Please find below the response to the review formulated for the CDM project "Sichuan Tongji-ang Gaokeng Hydropower Station Project" with the registration number 2147. In case you have any further inquiries please let us know as we kindly assist you.

Response to the CDM Executive Board

Figure 1. Power values in the project PDR

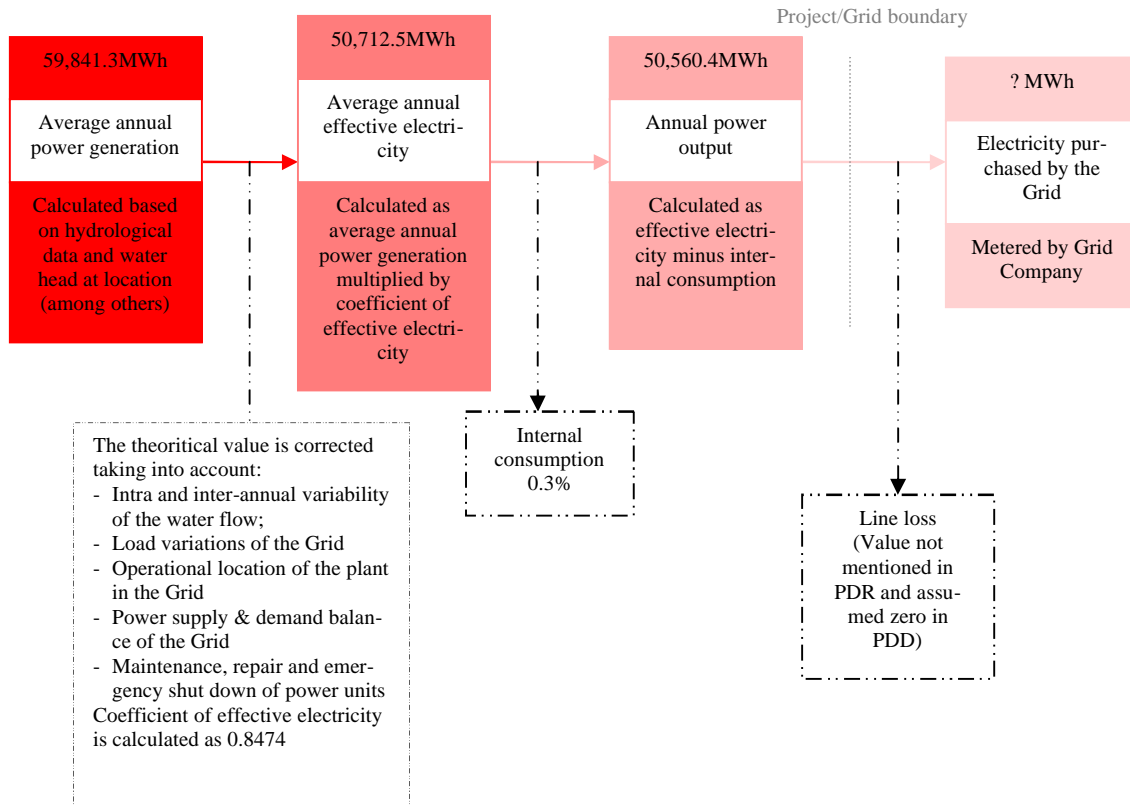
The PDD states that the expected annual power generation is 59.84 million kWh. However the net export to the grid is expected to be 50.56 million kWh. This loss of in excess of 15% of power generation should be further explained.

For further clarification, Figure 1 below summarizes the different power values mentioned in the project PDR

We conclude that the loss of 15.5% between the value of expected annual power generation and the value of net export to the grid can be further explained through the fact that:

1. A coefficient of effective electricity of 0.8474 was applied to the theoretical average annual power generation (59.84 Million KWh) in the PDR by the Design Institute in order to reflect the Intra and inter-annual variability of the water flow, the load variations of the Grid, the operational location of the plant in the Grid, the power supply & demand balance of the Grid as well as the maintenance, repair and emergency shut down of power units. First, the appropriateness of the 0.8474 value was reconfirmed by the Design Institute in a Statement dated January 8th 2009. Second, the value is in line with the estimate of the Tongjiang County Power Grid Company. Third, the appropriateness of using effective electricity generation value in the calculation of power sales revenues is confirmed by the Official Guidance of the Ministry of Water Resources of the People's Republic of China. Fourth, the value of 0.8474 used in the PDR and PDD is conservative compared with official guidance which recommends a range of 0.7-0.8 for similar projects.

2. A 0.3% rate of internal consumption was applied, which is conservative compared to the official guidance.

Transmission loss that may occur between on-site step up station and the Grid transformer station was assumed zero in the PDR and in the PDD.
